**Cleeves Masterplan
Stakeholder Engagement & Public
Consultation**

Statement of Outcomes

September 2023

Title:	Stakeholder Engagement & Public Consultation Report	
Project:	20035 CRQMP Cleeves Riverside Project	
Prepared by:	Mary Hughes MIPI (Director)	
Signed:		
Date:	September 2023	
Issue:	Rev 02	
<p>© Copyright HRA PLANNING. All rights reserved. This report has been prepared for the exclusive use of the commissioning party and unless otherwise agreed in writing by HRA PLANNING, no other party may copy, reproduce, distribute, make use of, or rely on the contents of the report for any other purpose. No liability is accepted by HRA PLANNING for any use of this report, other than for the purposes for which it was originally prepared and provided. Opinions and information provided in this report are on the bases of HRA PLANNING using due skill, care and diligence in the preparation of the same and no explicit warranty is provided as to their accuracy. It should be noted and is expressly stated that no independent verification of any of the documents or information supplied to HRA PLANNING has been made.</p>

Figure 2.0 Masterplan Development

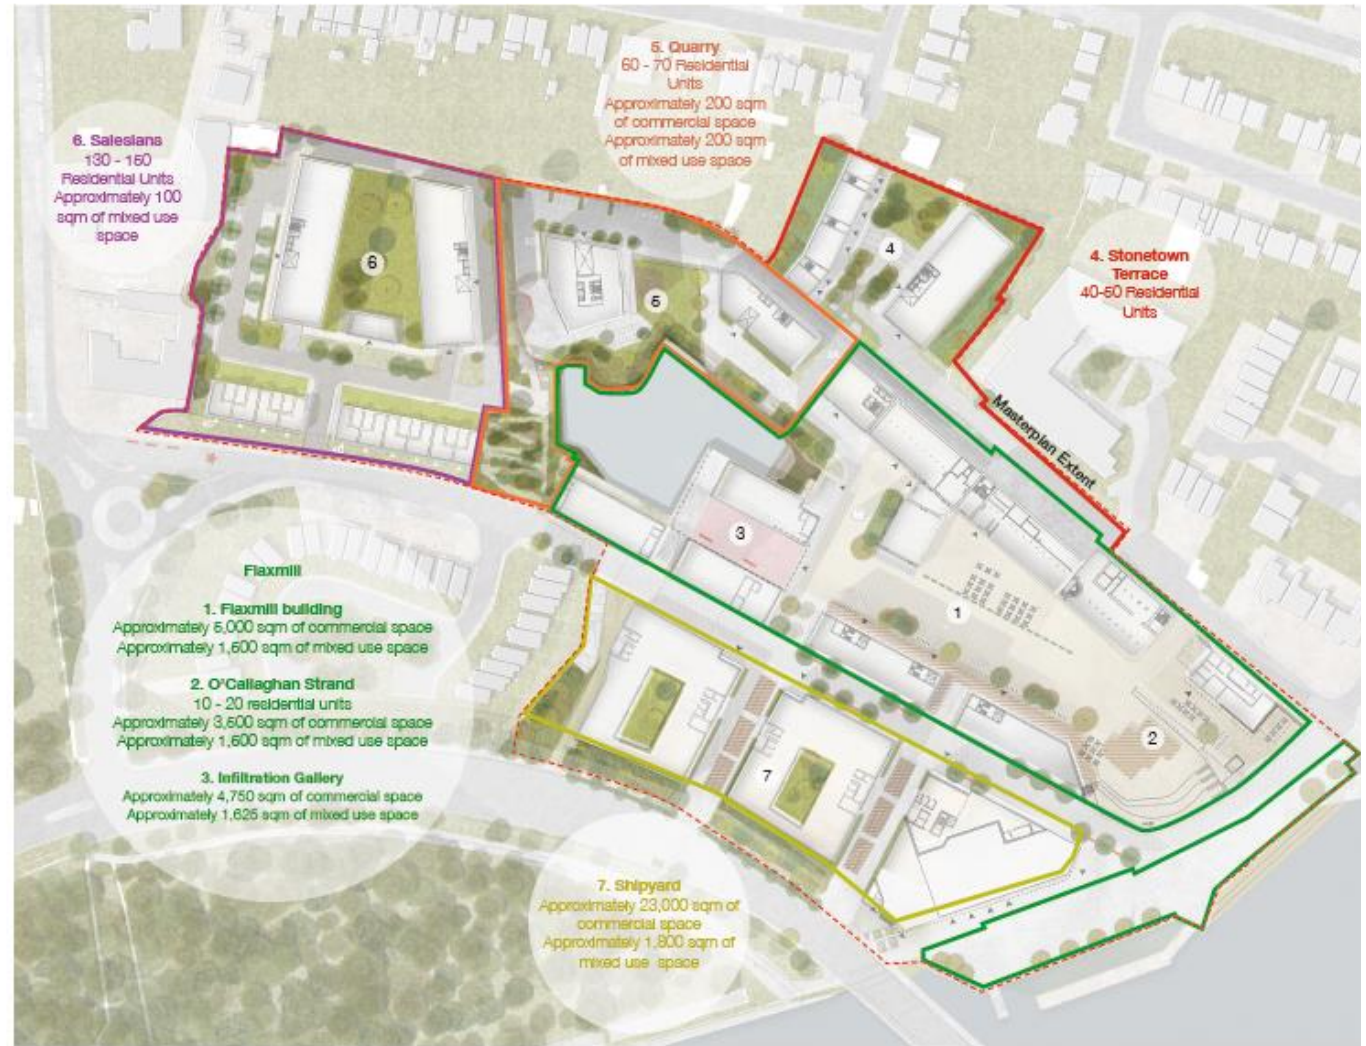
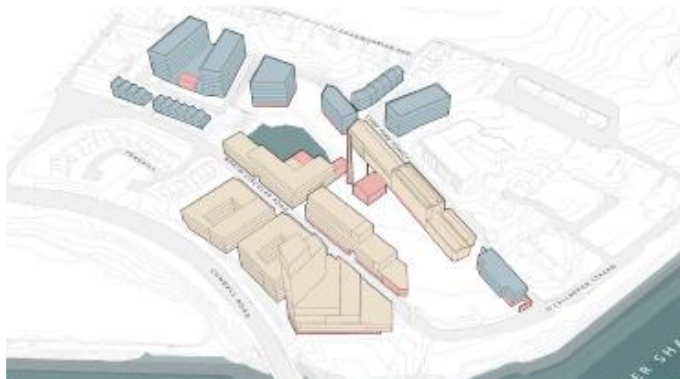
Figure 2.0 may need to be updated following review of quantum of accommodation by FCB
